Enclosure

Amendment Application No. 180,  
Revised Proposed Change Page 4.4-4  
and  
Revised Figure 3

**FIGURE 3**  
**MTS-8**

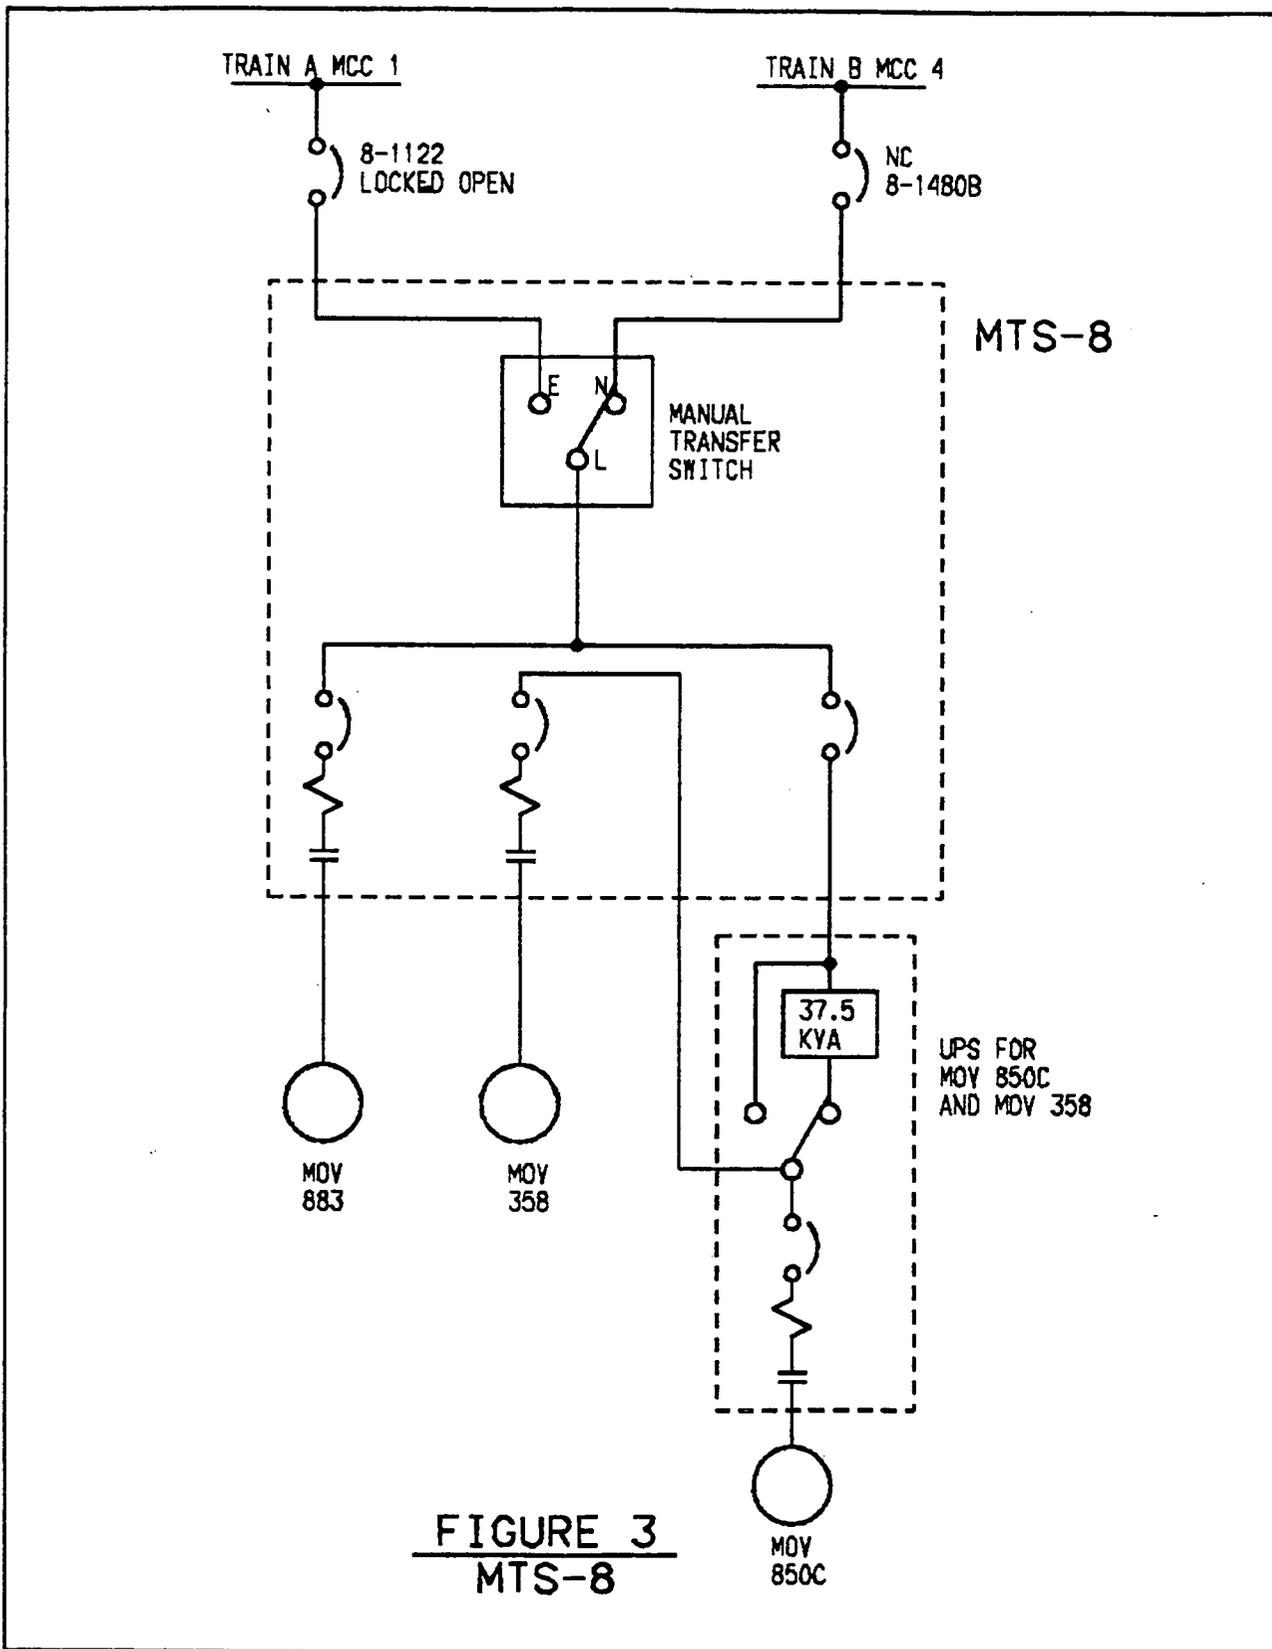
1. Verify once every 31 days that the fuse block for breaker 8-1181 in MCC-1 for MTS-7 is removed.
2. Verify once every 31 days that MTS-8 is energized from breaker 8-1480B from MCC-4 and the cabinet door is locked, and that breaker 8-1122 from MCC-1 is locked open.
